Replacement of Original

5 $\frac{3}{4}$ " (1A) Light Units with 100 watt Units

When replacing 12V 37 $\frac{1}{2}$ W and 50W (No. 1A) sealed beam light units with 100W units (Part No. 54523620), the following points should be observed.

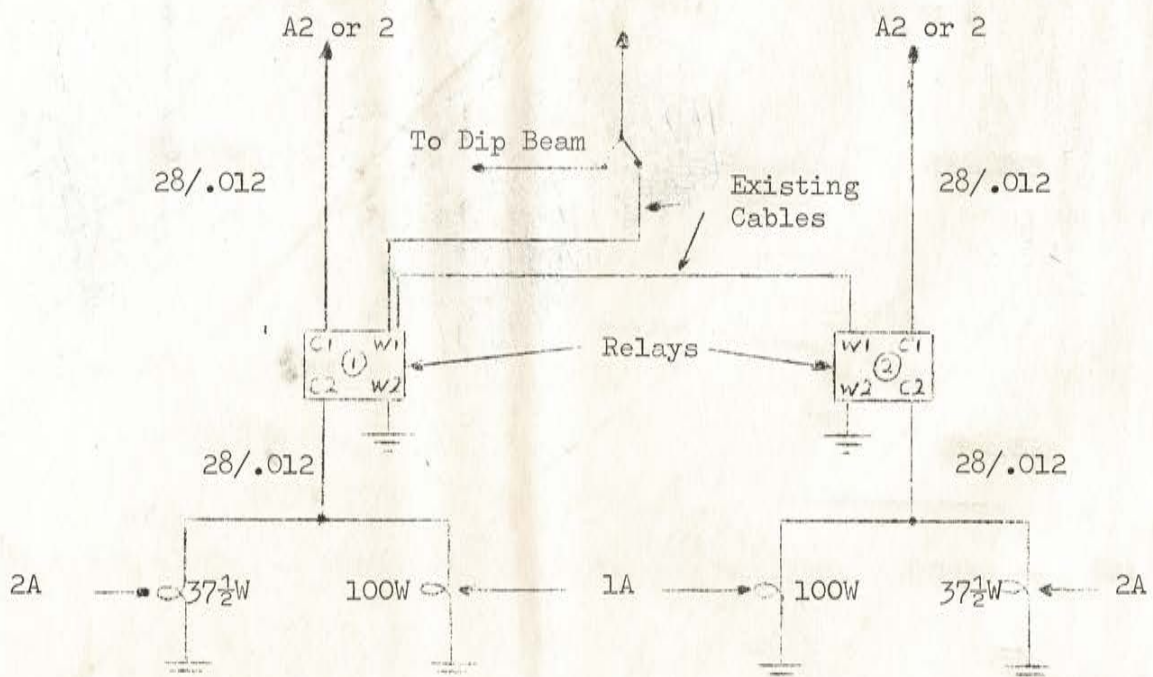
1. 100W units should only be fitted to vehicles equipped with charging systems capable of a minimum output of 30 Amps.
2. Connect 6RA relays (Part No. 33213) into the feed cables to each pair of headlamps (main beam only).
3. Feed cables to headlamps and relays must be capable of carrying the required current. Typical wiring circuit is shown below. Use 28/.012 (minimum) cables from fusebox (terminal A2 or 2) to each relay (terminal C1). Connect existing cable from dip switch, to relay 1 (terminal W1), and link to relay 2.
